**Town of Qualicum Beach
M E M O R A N D U M**

SUBJECT: Zoning Amendment: 103 Railway Street

To consider a zoning amendment application that would permit a 17-unit multi-residential building on the subject property.

1 SHADOW STUDY - SPRING/FALL EQUINOX @ 8a
1:50

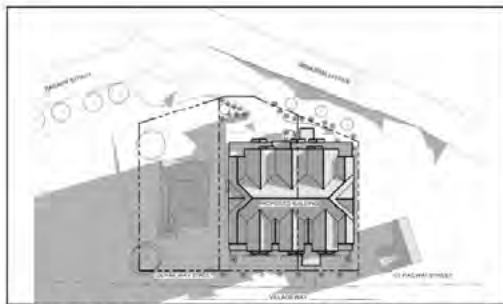
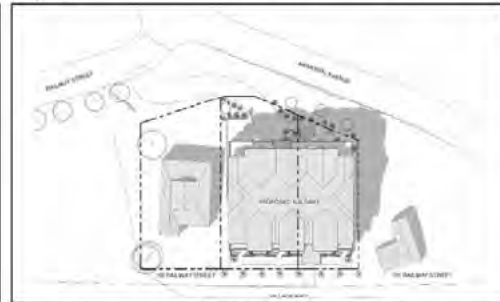
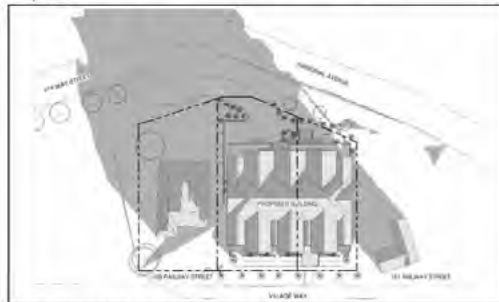
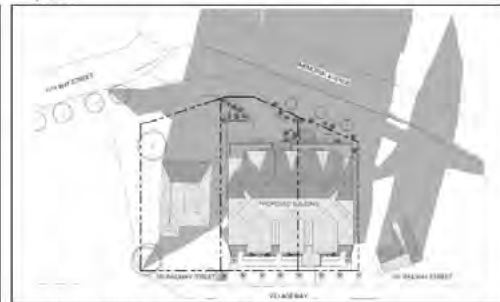
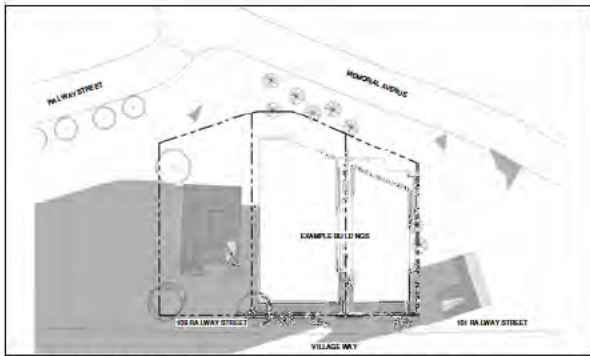
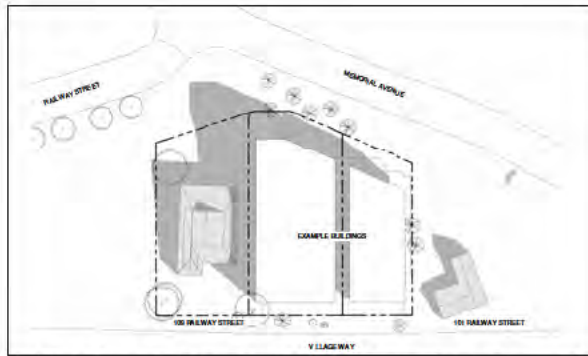
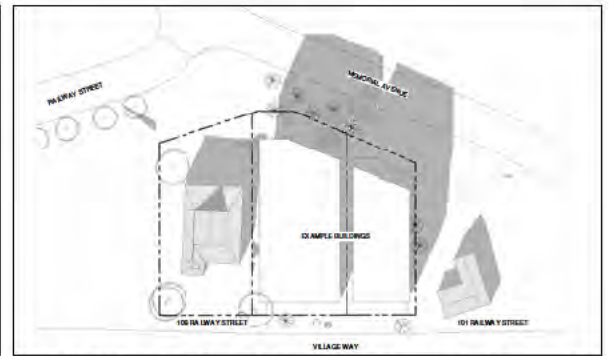
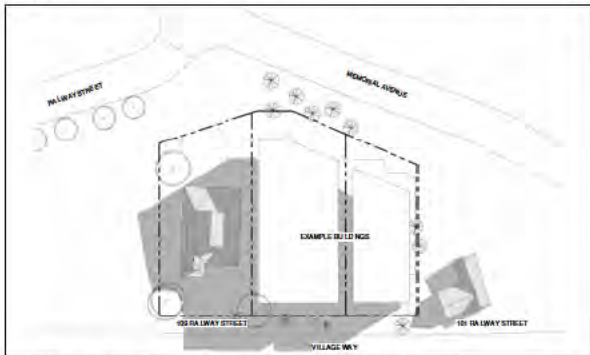
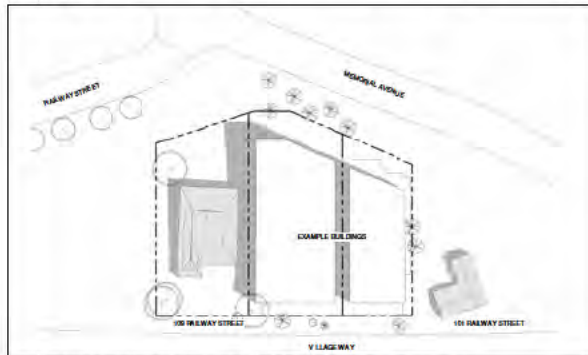
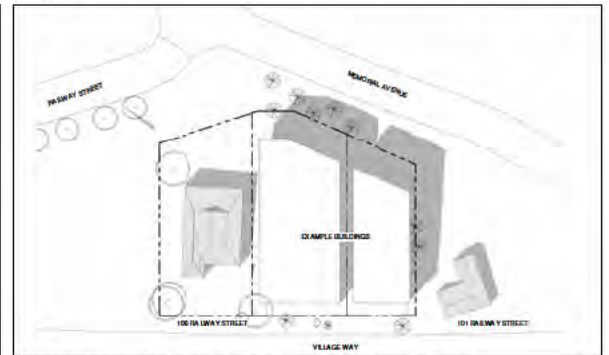
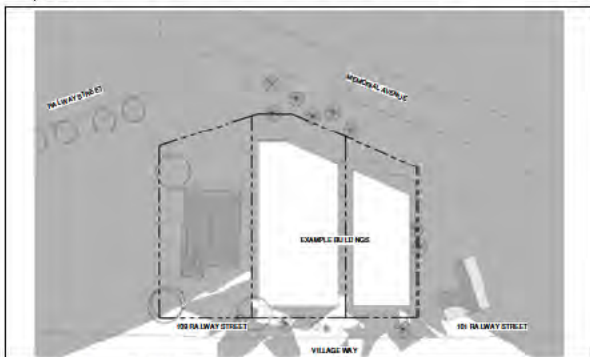
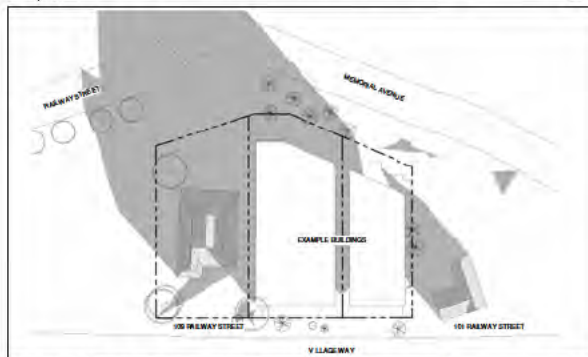
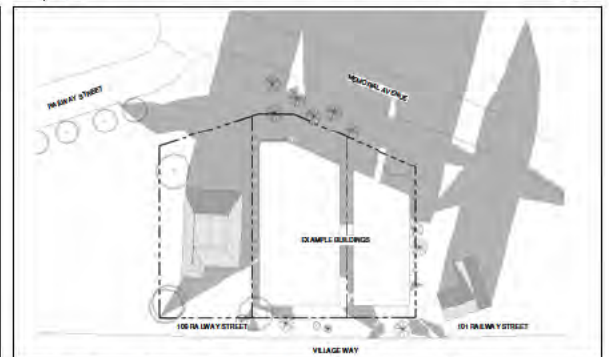
Two shadow studies have been provided by the applicant. One shadow study is for the current proposal and the second shadow study is for a two storey building as currently permitted under the zoning. Both shadow studies show that the building's shadow will be cast primarily to the north and west. The most significant impact will be on the single family dwelling to the west, as well as the streetscape along Memorial Avenue. Reducing the building height does not significantly increase the light to the west, as a lower building would still shadow the neighbouring property.

Sheet Title: LANDSCAPE PLAN

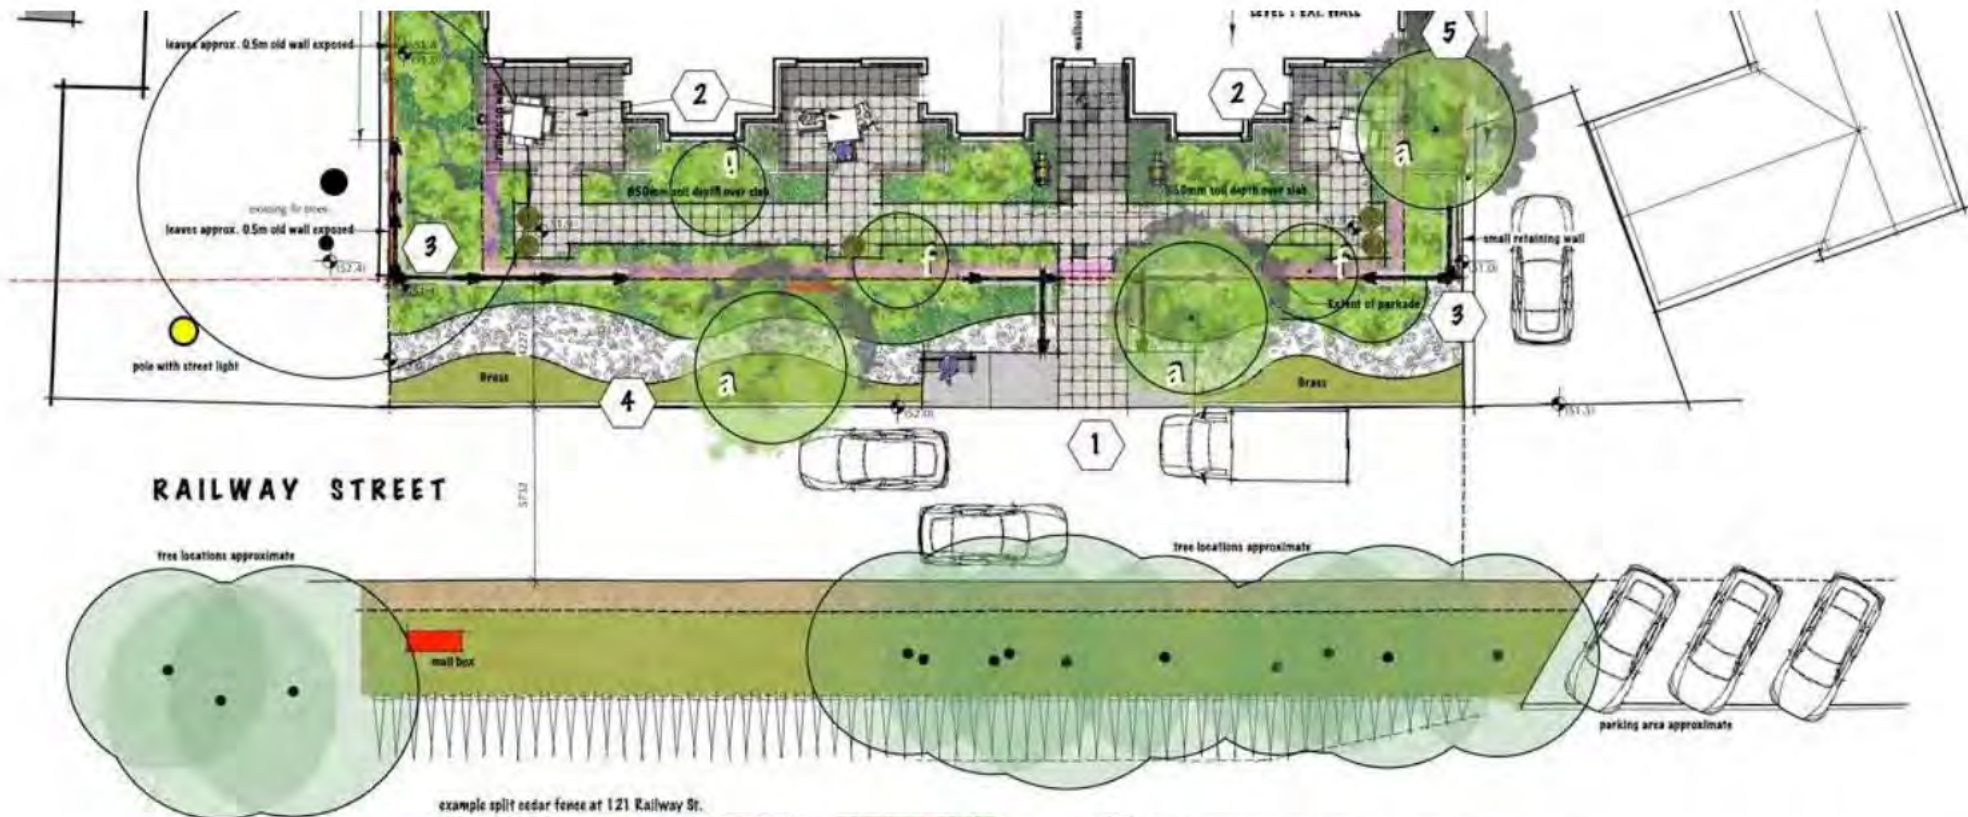
Staff Comment: A landscape plan has been submitted, which includes additional plantings. The applicant identified one existing tree on the parcel and has confirmed the tree will be removed.

Staff Comment: The proposed development includes trees and landscaping, but does not include sidewalks. However, no separate sidewalk is warranted, as Railway Street is a half-width road and intended to be pedestrian-oriented.
